| Intersection ID: 43146 | Main Street: EASTWAY_DR | Cross Street: EASTWAY_DR_RA | Location: | SW |
| ADA ID: 3ADE434C24D8 | Ramp Type: Perp | Initial Pass/Fail: Fail | Overall Compliance: No | Severity Score: 13.75 |

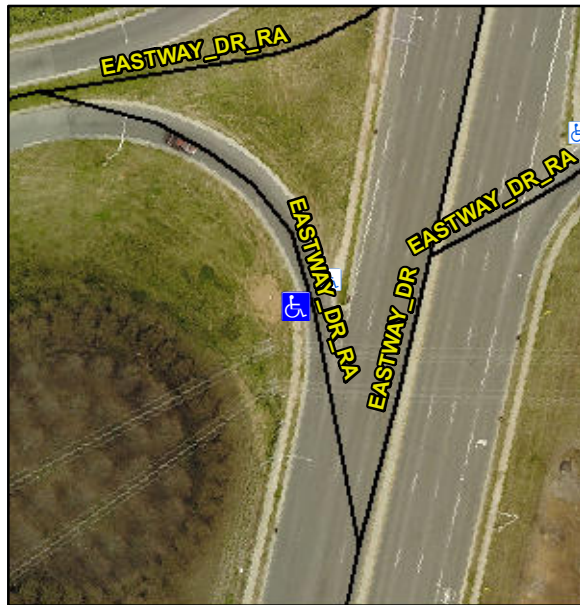
PROW/ADA:

Not Found, R304.2.2

| Compliance | Description | Data | Compliance | Description | Data |
|------------|-----------------------|-------|------------|-----------------------------|------|
| N/A | Ramp Length (in) | 82.5 | No | Ramp Slope (%) | 8.5 |

Possible Solutions:

Remove & Replace Entire Ramp.
